# City of Alexandria, Virginia

## MEMORANDUM

**SUBJECT:** COMMON ELEMENTS PALETTE FOR THE ALEXANDRIA WATERFRONT

**BOARD OF ARCHITECTURAL REVIEW  
2 DECEMBER 2015**

## INDUSTRIAL/WHARF

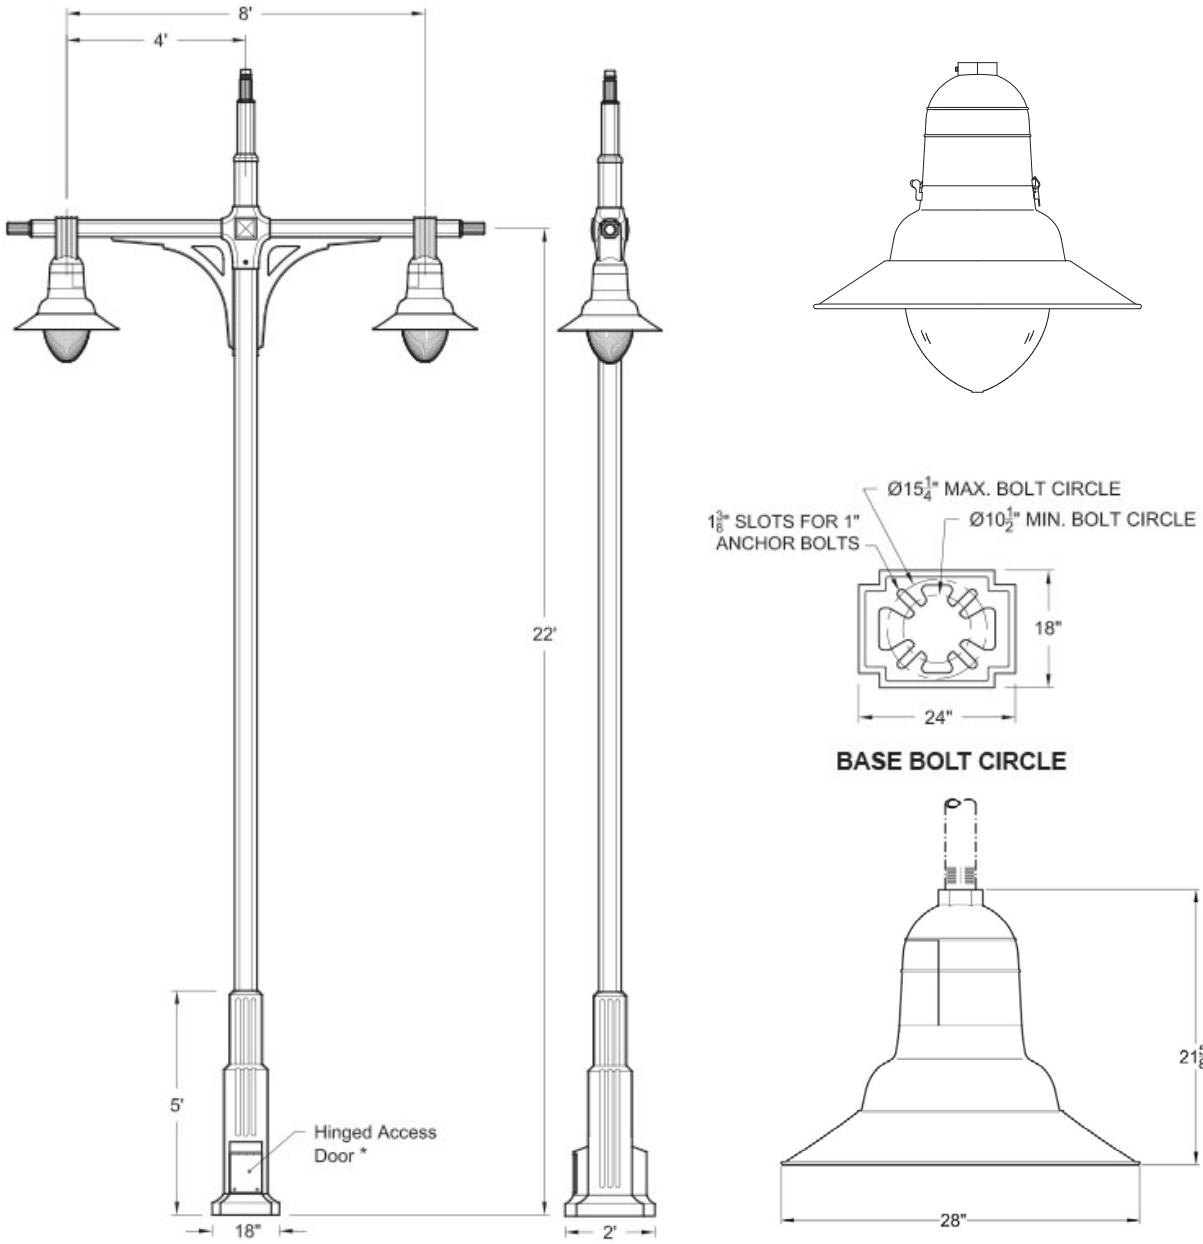
While an industrial or wharf-inspired light fixture may be appropriate on the historically commercial Alexandria waterfront, the example in the submission materials (Sheets 18 and 20) appears almost Art Deco and the Torpedo Factory is our only Art Deco building on the waterfront. Staff recommends that further examples in this direction be studied and could lead to a variation on either the industrial or combination schemes. Another option for a promenade light would be to utilize a variation of the George Washington Memorial Parkway light fixture which has been well-received in the community. Although the promenade would be a different context from the Parkway, it is a well-designed light that has its roots in Alexandria and having common parts for these two north-south corridors would make maintenance easier for the City.

The best option may be to select a contemporary but less stylized light that would function as a common and unifying *background* component, recognizing that the promenade itself and the Potomac River are the features, rather than a specific light fixture. Once the Waterfront Plan is realized, and portions of the area will be constructed as part of the approved redevelopment sites, there will be many engaging elements from historic interpretation to public art to ongoing activity, so that the promenade light itself will be less of a focus. Staff asks that the BAR provide design direction for the landscape consultants at this time to clarify what style and type of light are appropriate for the promenade.

Staff recommends that the BAR support the proposed design direction for paving on the streets, including The Strand, and the promenade, as well as Art and History elements. Staff recommends that the design team continue to study an appropriate promenade light and return with alternatives. When selecting this light, consideration should also be given to light fixtures within the public parks, street end gardens, public piers and the marina, etc. Future Common Element materials, not limited to bollards, marina power pedestals, railings, additional lighting and fixed furniture, should always relate to the adopted Common Elements palette and will be reviewed at a later date.

## COMBINATION

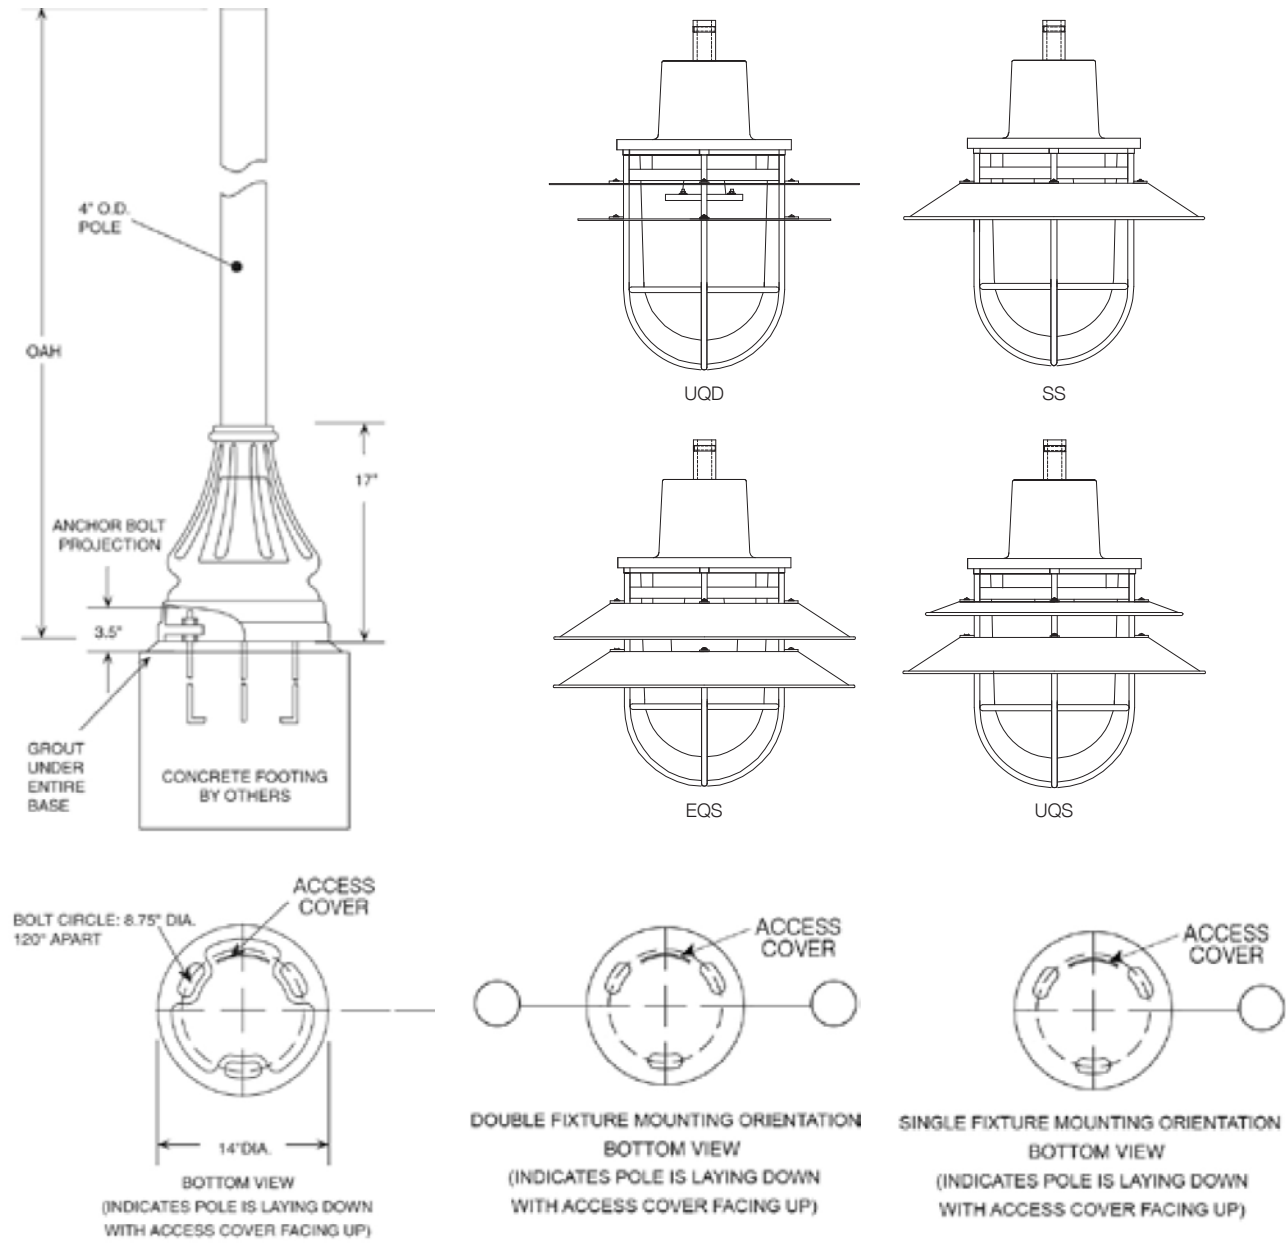
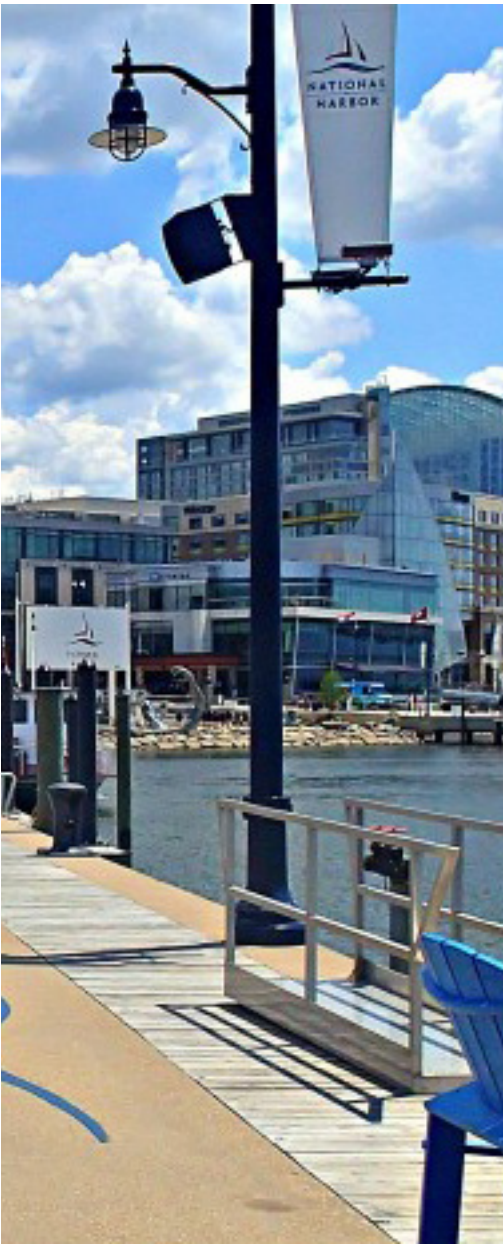
Staff finds that the area that needs additional work at this time relates to lighting. Staff is currently studying the feasibility of a more historically appropriate Gadsby light for portions of the historic district that will be more energy efficient and more consistent with historic streetlights in Alexandria. The proposed Gadsby light prototype will be installed in the 300 block of Cameron Street within the coming months and will likely be an appropriate streetlight for both the street areas in the waterfront as well as the greater “Gadsby Light District” in Old Town. The design team has proposed four general lighting approaches for the promenade: period/historic, industrial/wharf, nautical/cable, and a combination design (modern pole and industrial pendant light fixture). Although the slightly nautical/cable fixture is included in the package as Alternative 3, it was not warmly received by the Parks and Recreation Commission or the Waterfront Commission, and as a result the “combination” design has been included in this iteration.

Selecting an appropriate promenade light fixture, one that will link both the industrial character of the marina in front of the Torpedo Factory with open park space with existing residential buildings is challenging. There is no one “character” that defines the entire waterfront and a stylized light fixture runs the risk of being incongruous with some of the various contexts in which it will exist. No doubt, the promenade is a unique and special zone, so the idea of a unique and special light fixture along its length is appropriate for the reasons previously described. Because the Gadsby streetlights will be on the streets of Old Town, it does not seem to be a unique fixture for the waterfront promenade. With the possible introduction of a new, more historically appropriate Gadsby streetlight, it seems odd to select a similar but different and decidedly historicist or period light on the promenade that may cause visitors and residents to wonder which is the true historic streetlight.
